Sub: Joint Meeting of the Standing Committee on Power System Planning of
Southern Region and Western Region - Minutes of the meeting

Minutes for Joint Meeting of Standing Committee on Power System Planning in Southern Region and Western Region **held on 20 April, 2015 at NRPC, Katwaria Saria, New Delhi**

2.0 Modification proposed by PGCIL in Raigarh-Pugalur- Kerala 6000 MW HVDC System

SYSTEM STUDIES : Southern Region 2018-19

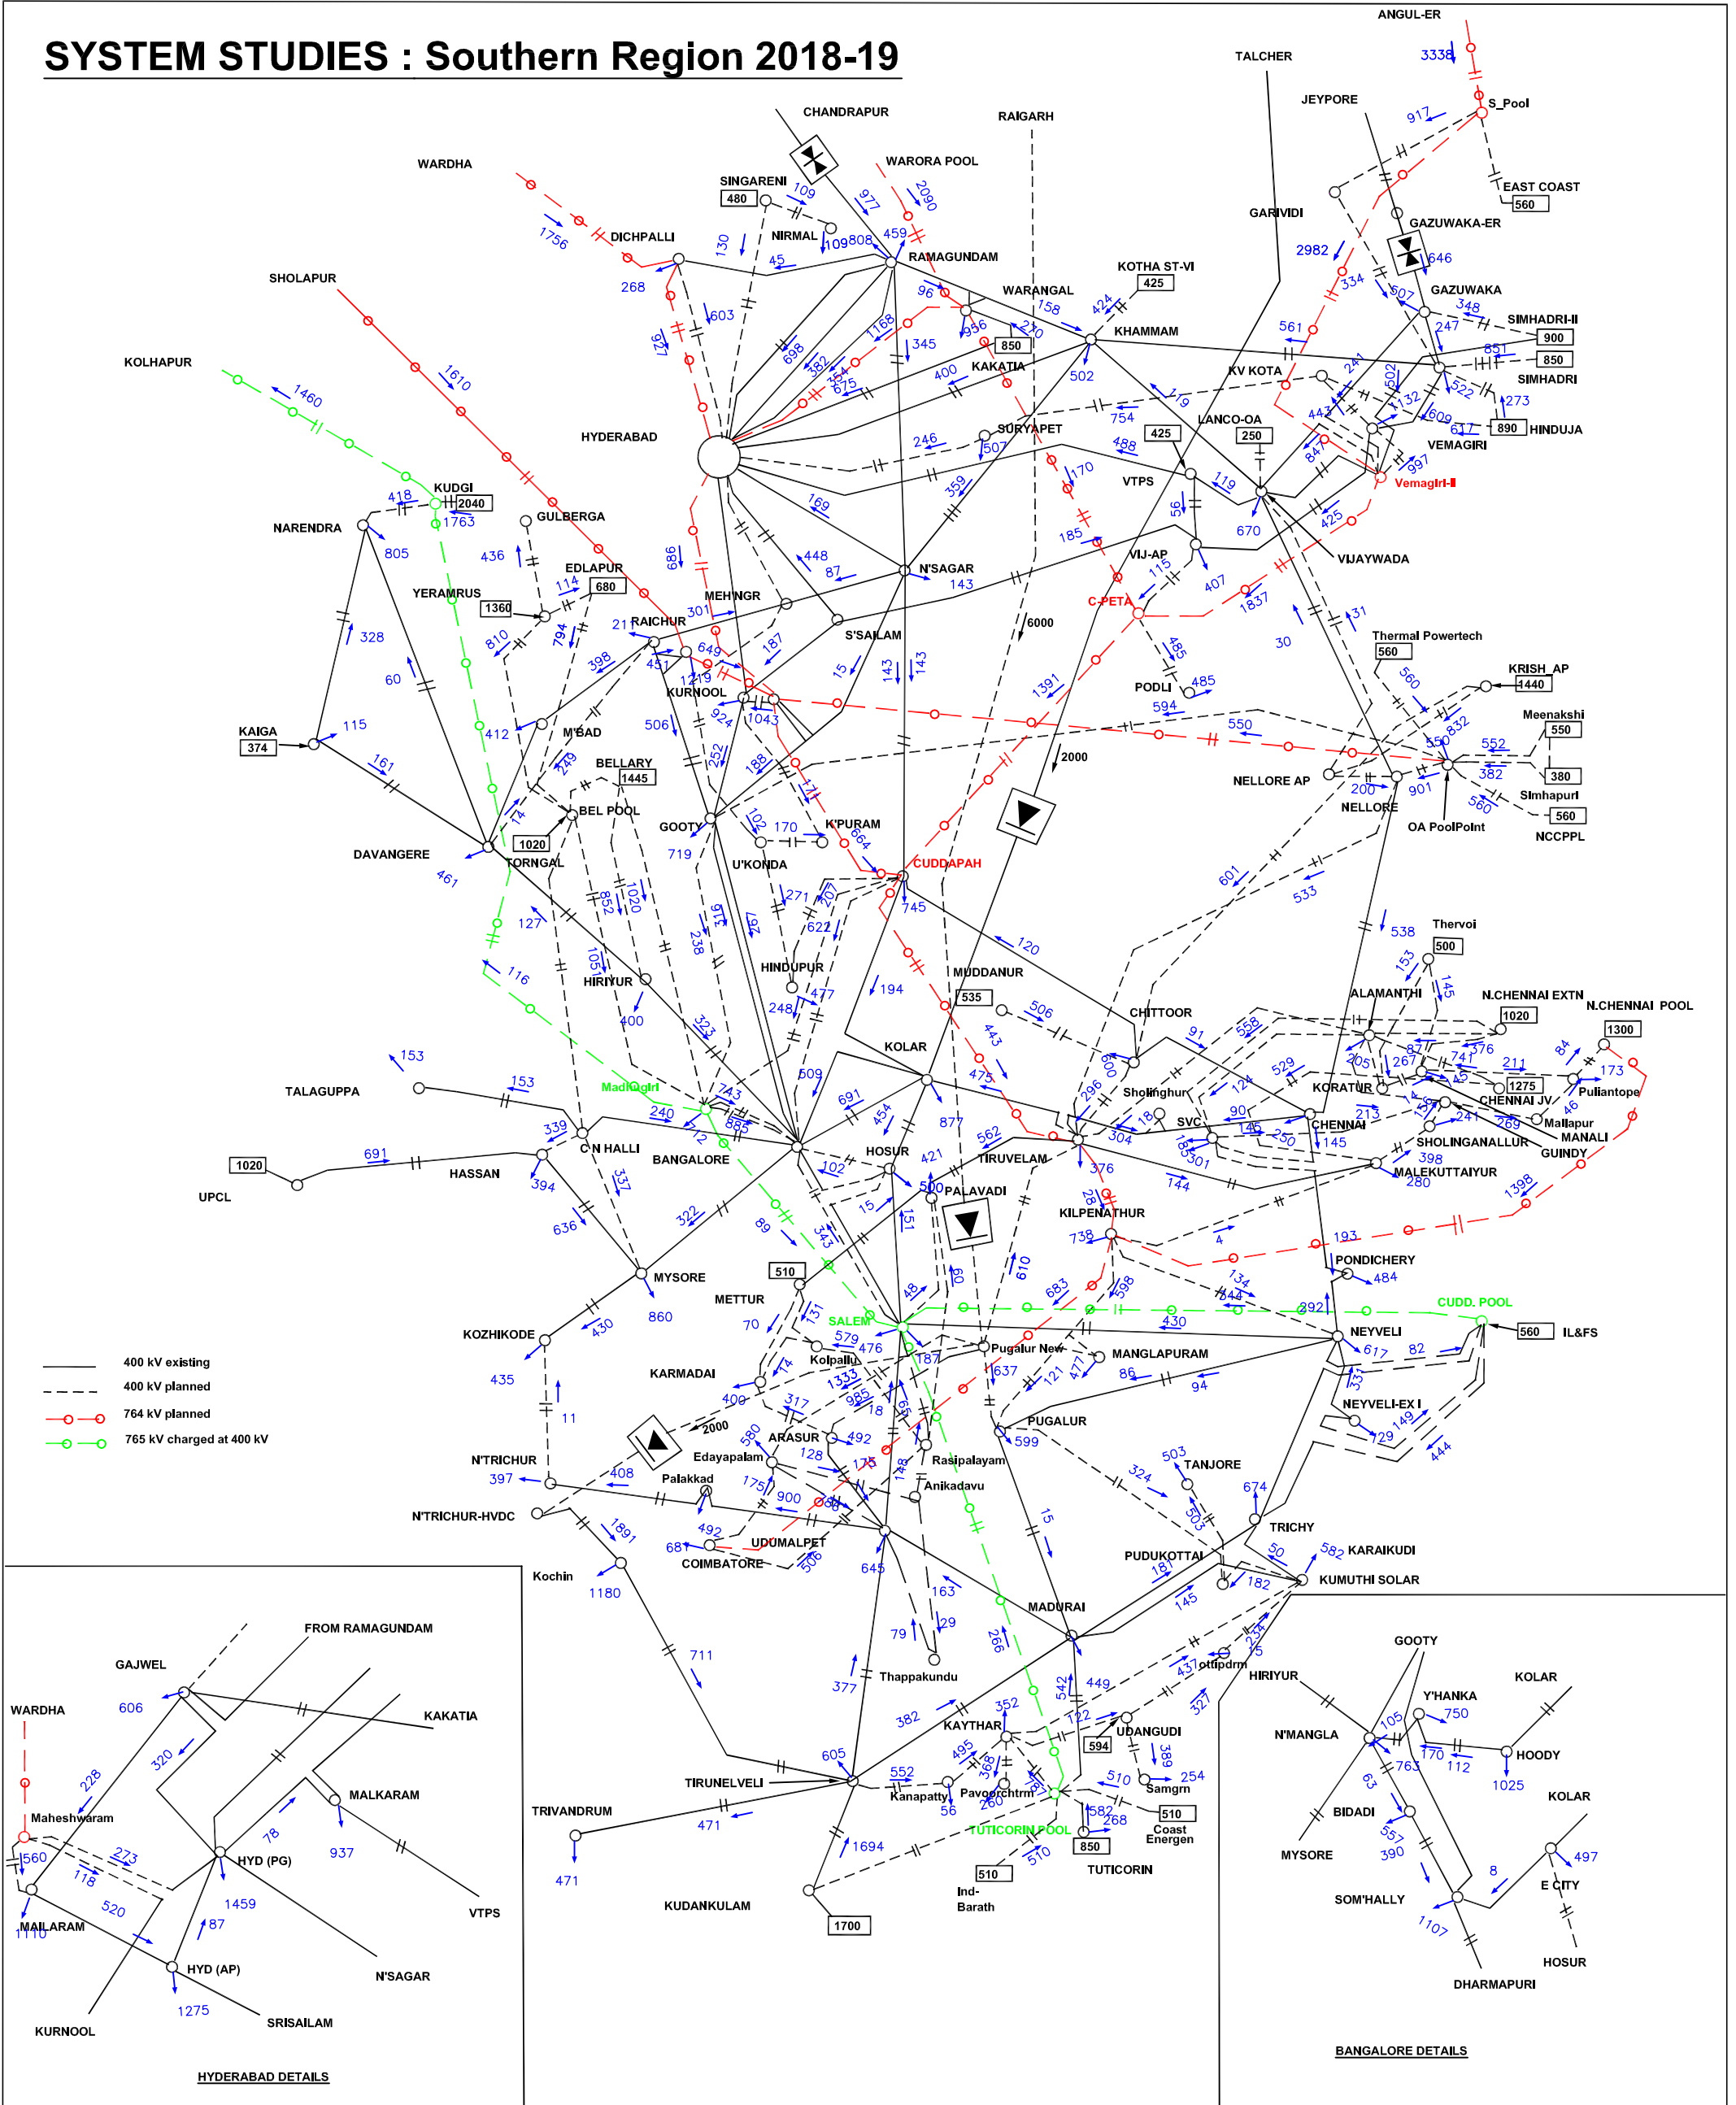
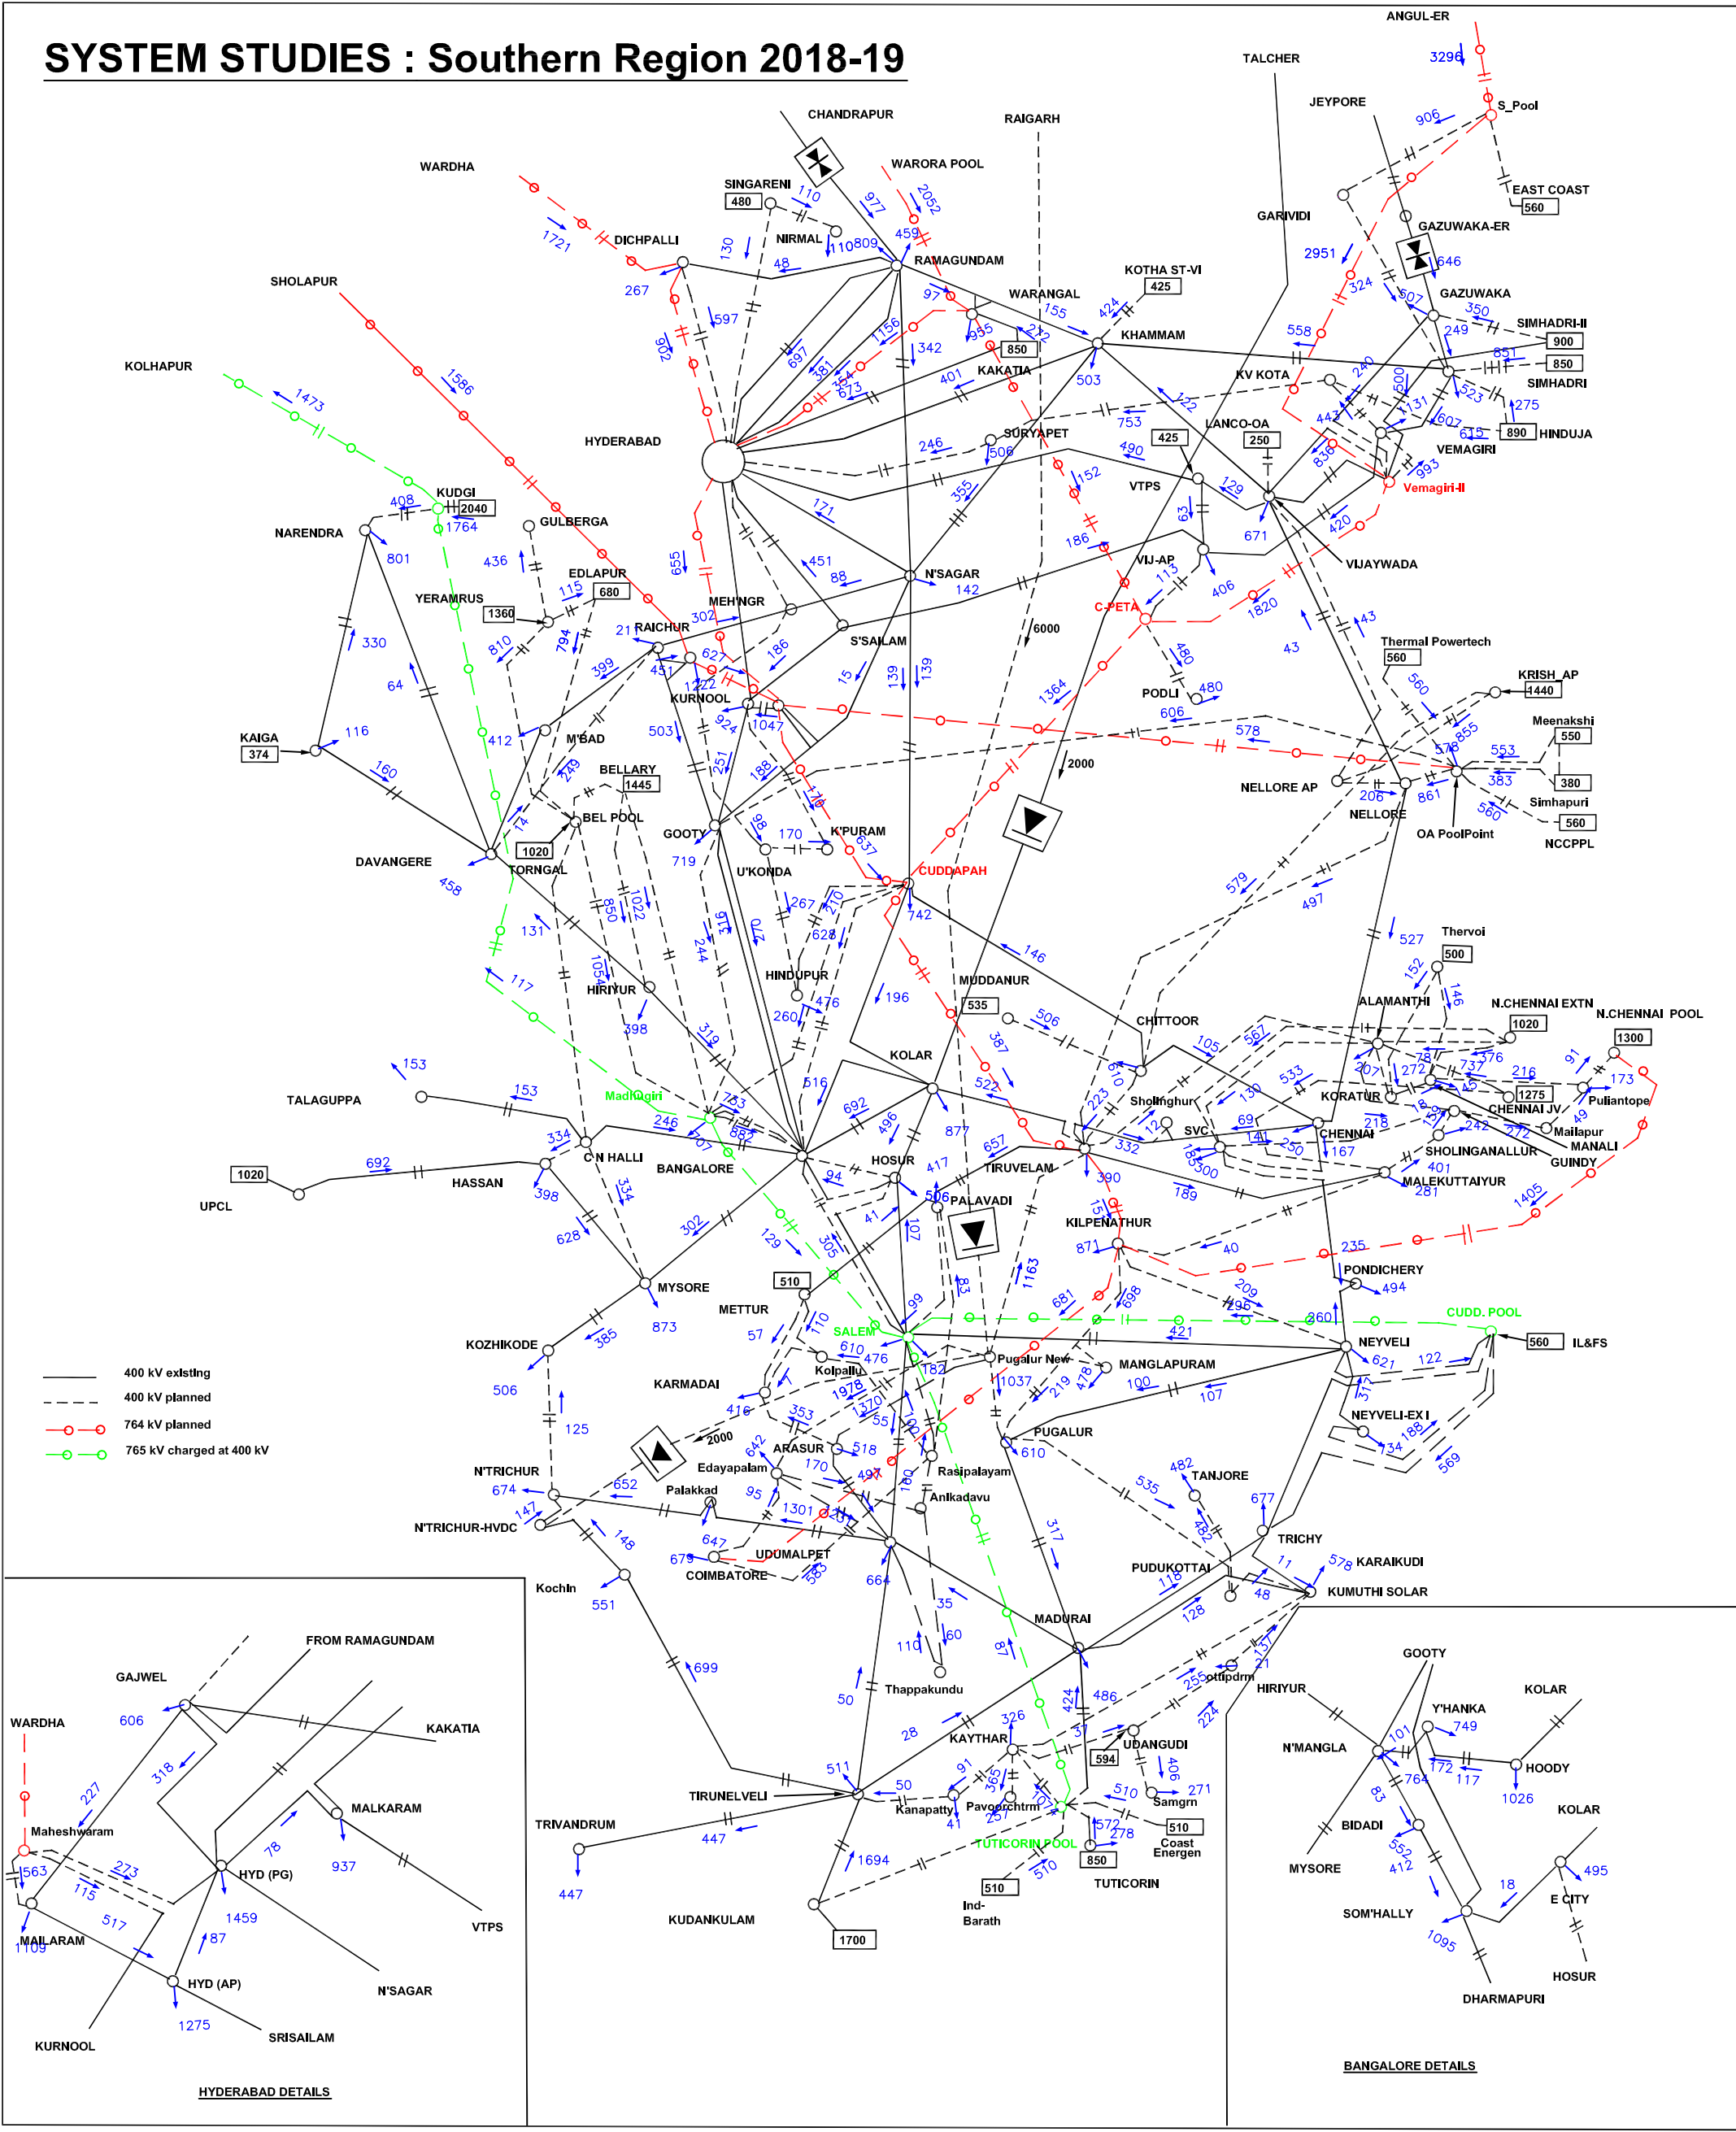
- n. **System Studies for** inter connection of North Trichur HVDC Station with 400kV system in Kerala. Indicative transmission system strengthening required in Kerala state network, so that 2000 MW gets absorbed in the Kerala without overloading/congestion of the 220kV or 110kV network in Kerala. It is requested that corresponding loadflow and SLD file may also be sent to CEA.

(n):System Studies for inter connection of North Trichur HVDC Station with 400kV system in Kerala. Indicative transmission system strengthening required in Kerala state network, so that 2000 MW gets absorbed in the Kerala without overloading/congestion of the 220kV or 110kV network in Kerala. It is requested that corresponding load flow and SLD file may also be sent to CEA.

Reply- Studies has been carried out with 2000MW injection at North Trichur. Injection is through LILO of Cochin-North Trichur 400kV D/c (Quad line). The total load of Kerala is about 5425MW which is met by self-generation of 1360MW and import of 4065MW. The details of tie line flows are shown in Exhibit-I. From the Exhibit-I it is seen that Edamon-Tirunellveli is loaded to 363MW per circuit. Under one pole outage the loading on the line increases to 376MW on each circuit. For above load-generation balance in the absence of proposed HVDC bipole, loading on Edamon-Tirunellveli is 390MW per circuit.

Load flow simulations are plotted in **Exhibit-II & III**. Under (n-1) condition, no constraint is envisaged on line loadings around North Trichur. However, transformers at Cochin and North Trichur gets loaded to 694MW (630MW) and 780MW (630MVA) even under base case. Transformers augmentation as proposed during 37th SCM needs to be taken up with matching 220kV augmentation. Under (n-1-1) contingency if both North Trichur-North Trichur (HVDC) are taken under outage then the entire power would flow towards Kochin and about 1285MW is dropped through transformers and remaining power flows towards Tirunelveli. Strengthening of 220kV to be taken up at Kochin.

In case-1 the 220kV network around Kochin area gets highly over loaded. For Exhibit-2b power flow on HVDC is restricted to 600 MW and load of Kerala to 3850MW to bring the transformer loading on Cochin within the limits (610MW).
